Access Compliance Report Public Rights-of-Way (Curb Ramps)

Intersection ID: 47108Main Street:FRANK_LITTLE_CTCross Street:ERNEST_RUSSELL_CTLocation:NEADA ID: 3F416669441BRamp Type:PerpInitial Pass/Fail:FailOverall Compliance:NoSeverity Score:13.75

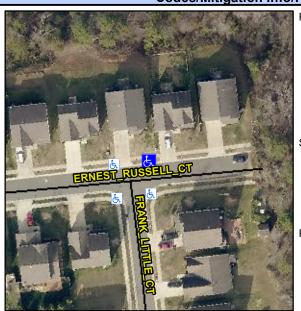
T CCCIDIC CCIALICIT	
Possible Solutions:	Co
Remove & Replace Entire Ramp.	N/A
	Ye
	N/A
	N/A
	N/A
	N/A
Surveyor Notes:	N/A
N/A	N/A
	N/A
	N/A
	N/A
PROW/ADA:	N/A
Not Found, R304.2.2, R304.5.3	N/A
	N/A
	N/.
	N/A

Field Measurements/Component Compliance						
Comp	liance Description	Data	Comp	liance Description	Data	
N/A	Ramp Length (in)	47.0	No	Ramp Slope (%)	10.6	
Yes	Ramp Width (in)	49.0	No	Ramp XSlope (%)	4.4	
N/A	Flare Type LT	N/A	N/A	Flare Type RT	N/A	
N/A	Flare Slope LT (%)	N/A	N/A	Flare Slope RT (%)	N/A	
N/A	Flare Traversable LT?	N/A	N/A	Flare Traversable RT?	N/A	
N/A	Landing Length (in)	N/A	N/A	DWS Provided?	N/A	
N/A	Landing Width (in)	N/A	N/A	DWS Contrast?	N/A	
N/A	Landing Slope (%)	N/A	N/A	DWS Length (in)	N/A	
N/A	Landing X Slope (%)	N/A	N/A	DWS Full Width?	N/A	
N/A	Landing Curb? (Y/N)	N/A	N/A	DWS Offset (in)	N/A	
N/A	Shared Landing?	N/A				
N/A	Gutter Ponding?	N/A	N/A	Gutter Slope (%)	N/A	
N/A	Gutter Lip Ht (in)	N/A	N/A	Gutter X Slope (%)	N/A	
N/A	Painted X Walk1?	No	N/A	Painted X Walk2?	N/A	
	X Walk 1 Direction	To S		X Walk 2 Direction	N/A	
N/A	X Walk 1 Width (in)	N/A	N/A	X Walk 2 Width (in)	N/A	
	X Walk 1 Slope (%)	3.6		X Walk 2 Slope (%)	N/A

X Walk 1 X Slope (%)	4.0		X Walk 2 X Slope (%)	N/A	
N/A	Ramp inside XWalk1?	N/A	N/A	Ramp inside XWalk2?	N/A	
	Road Slope (%)	N/A	N/A	Clear Space?	N/A	
	Road X Slope (%)	N/A	N/A	Clear Space to XWalk (in)	N/A	
N/A	Any Obstructions?	N/A	N/A	Storm Grate/Utility Hazard?	N/A	
	Obstruction Type			Storm Grate/Utility Type		
		N/A			N/A	
			Yes	Surface Condition? (G/P)	Good
